**MetroLink**

## **Additional Errata Relating to Chapter 20**

Document Title: Additional Errata Relating to Chapter 20

Chapter 20 addresses Geology and Soils within the EIAR.

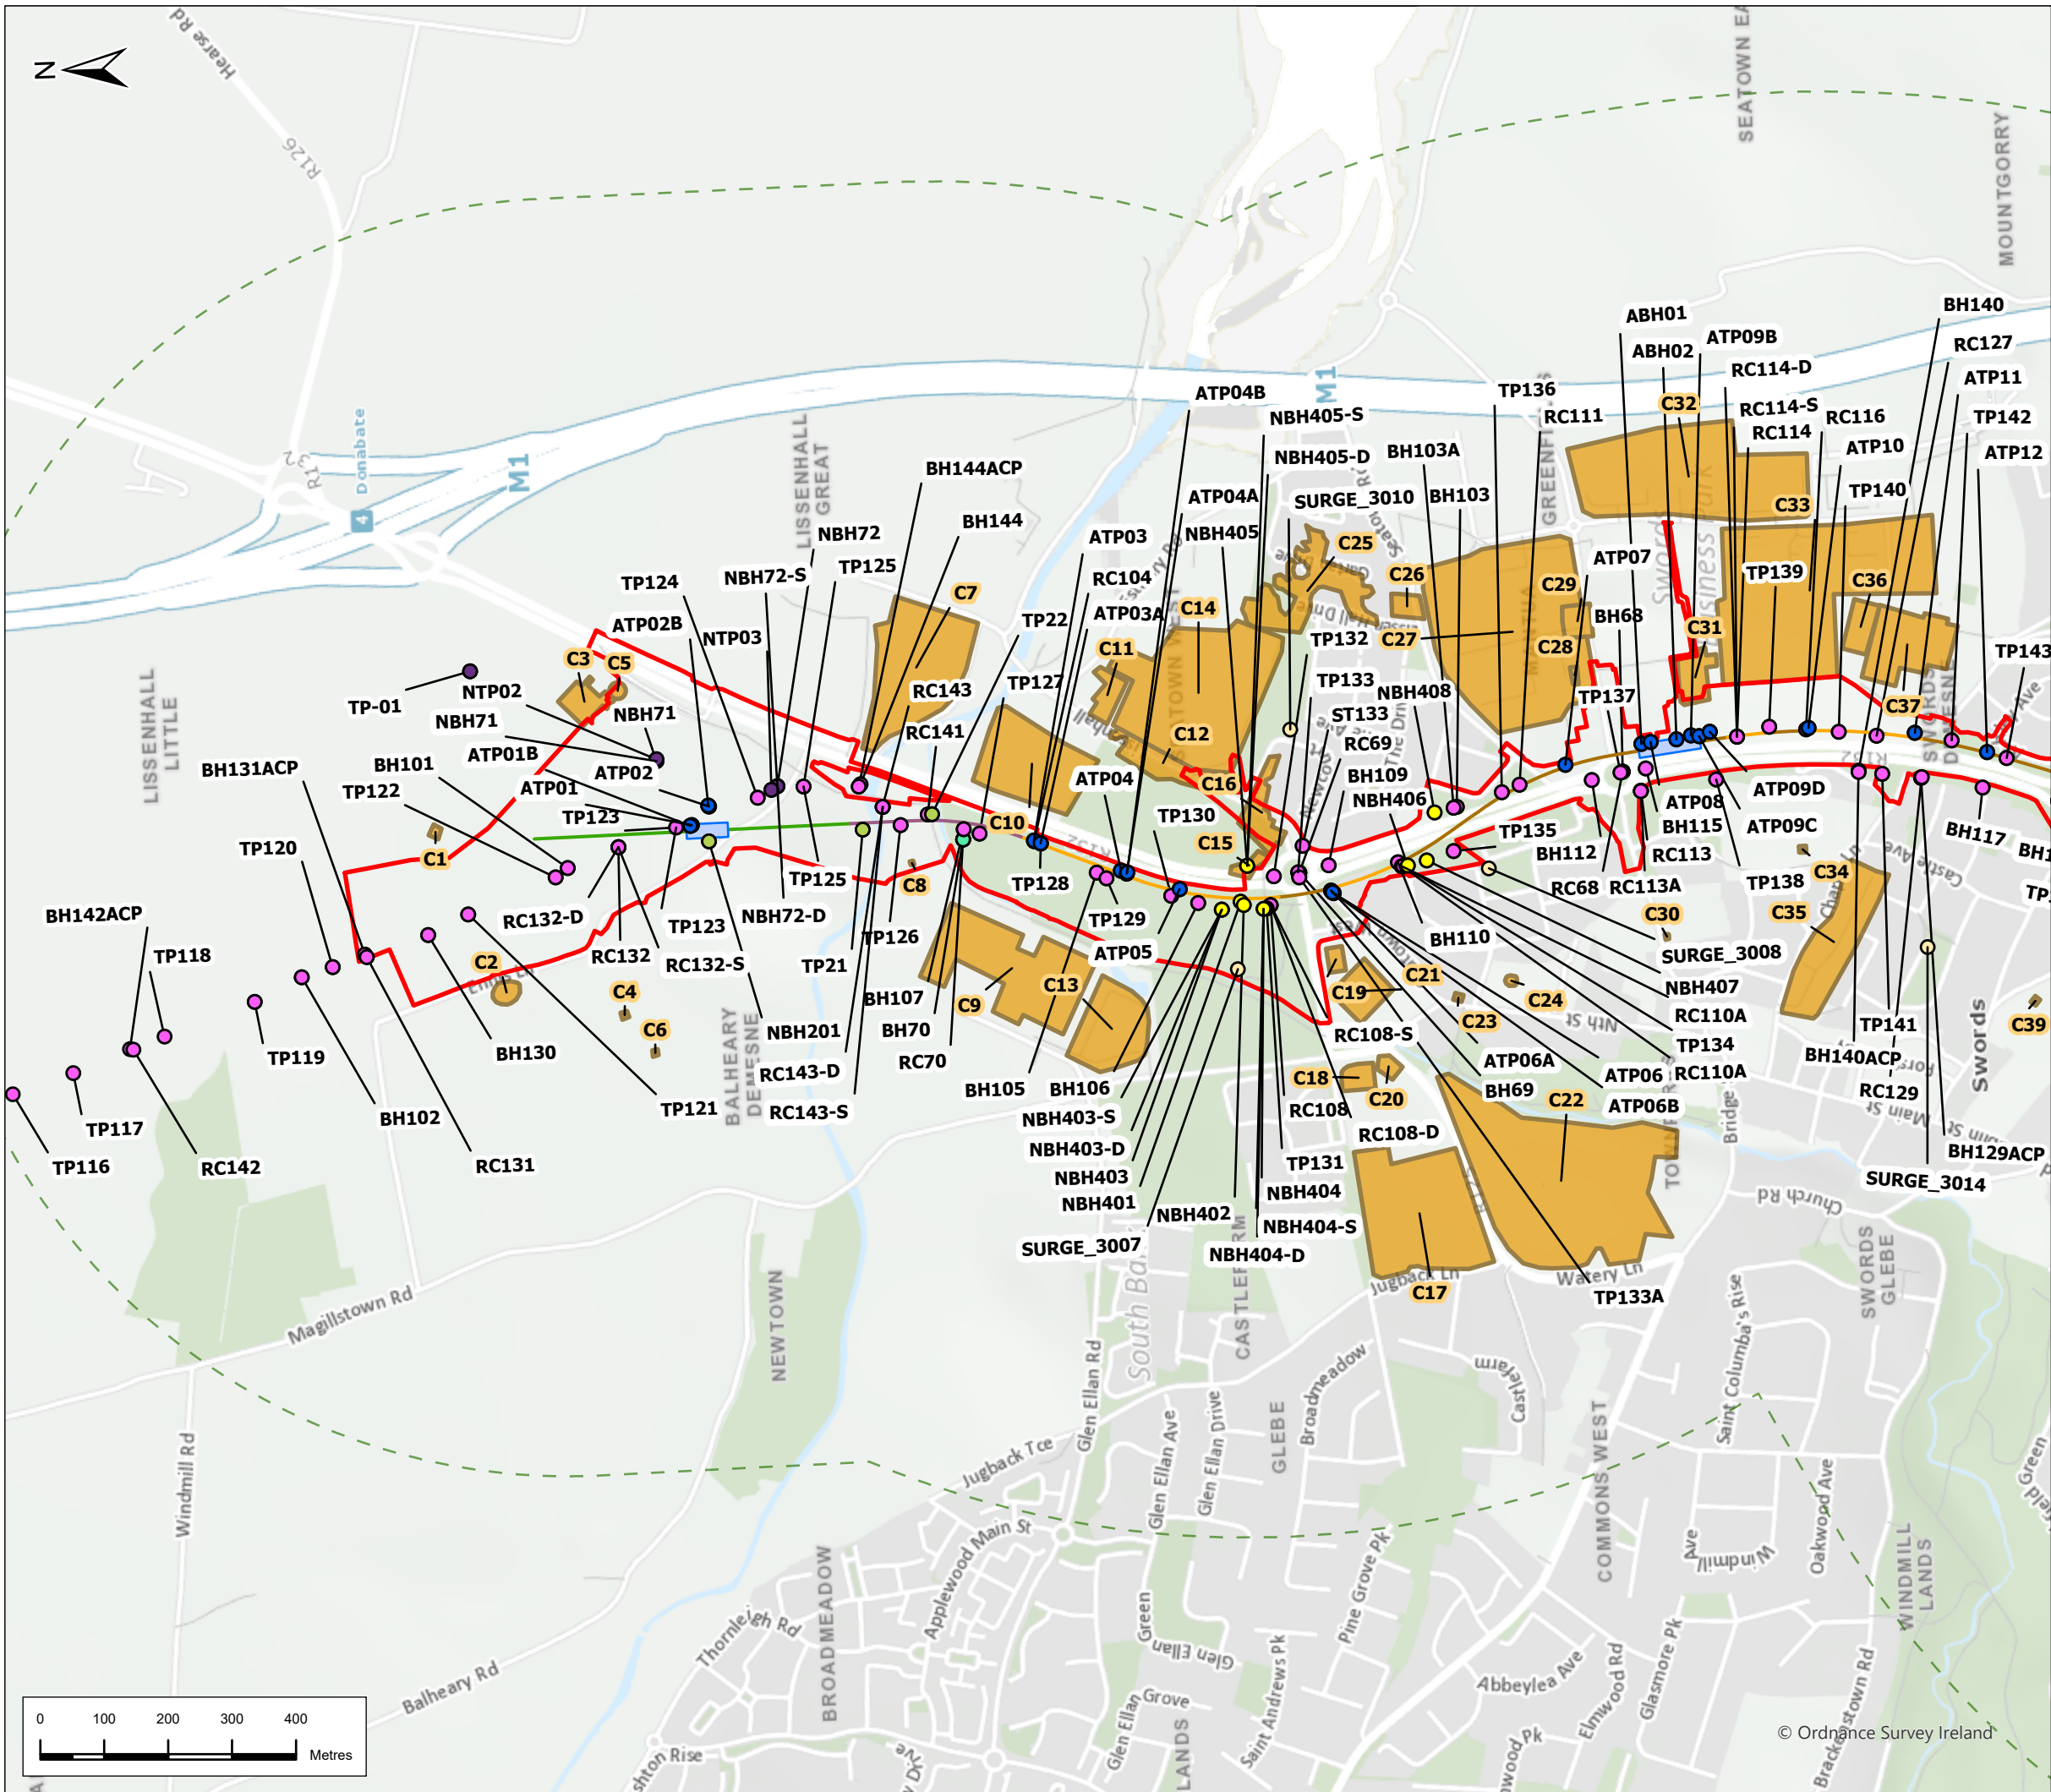
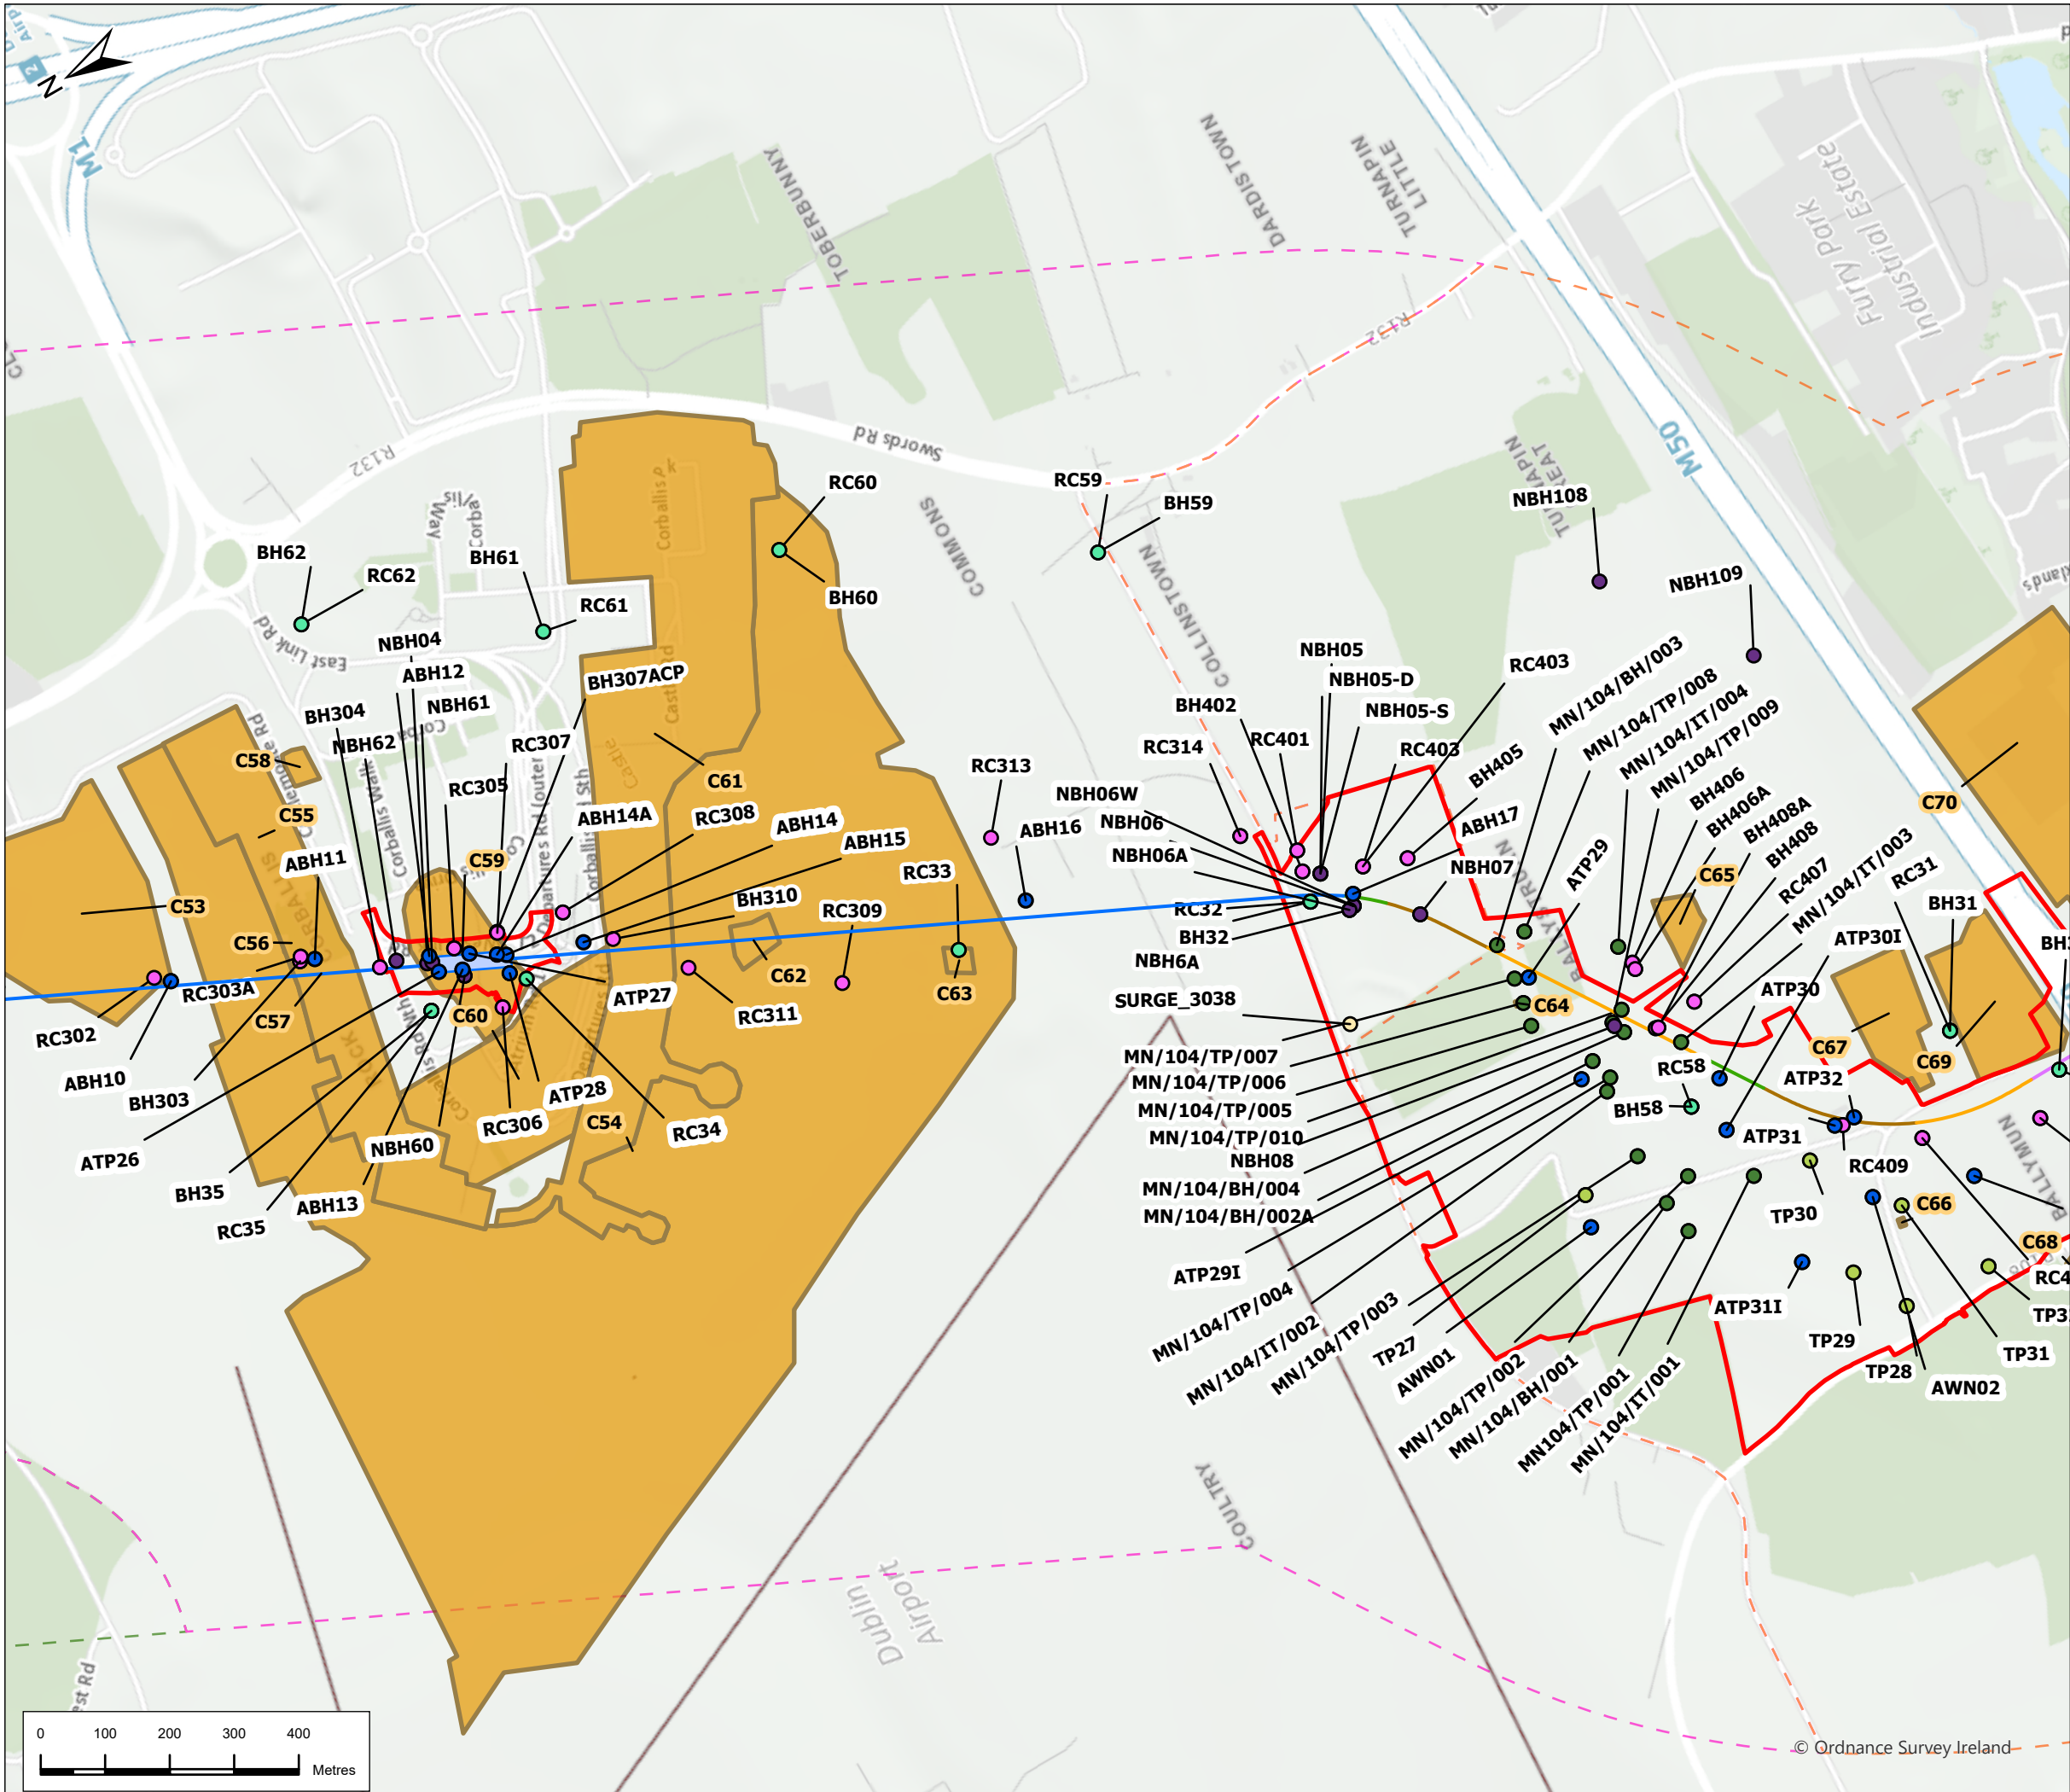
It has become clear during the course of the oral hearing that, in error, borehole locations which appeared in an early drawing of proposed bore hole locations, and which did not form part of the Geotechnical Investigation (GI) scope, were included in error in the chapter presentation as follows:

- Figure 20.6 (Revised version attached)
- Appendix A20.1 (Summary of Supporting Ground Investigation Scope)
- Appendix A20.2 (Summary of Relevant Exploratory Hole Locations and Monitoring data)
- Appendix 20.8 (Appendix A Tables A1 to A4) and Figure 20.6.

Chapter 20 includes summaries of the ground investigation (GI) data used in development of the assessment as detailed above as well as a figure detailing the GI locations. An error has been identified whereby proposed borehole locations which were not actually drilled were included in the summary tables detailed above and Figure 20.6. These borehole locations were not drilled as they were not required. The proposed Phase 1 borehole references included in error are listed in Table 1.

The inclusion of these proposed GI location references was mistaken, and it should be noted that boreholes at these proposed GI locations were not drilled. Consequently, there is no data associated with these proposed locations.

The geological cross sections included within the EIAR were developed on the basis of the GI locations actually completed and, as such, are not affected. The resulting interpretation of geology included in Chapter 20 (Soils and Geology) and Chapter 19 (Hydrogeology) is unchanged.
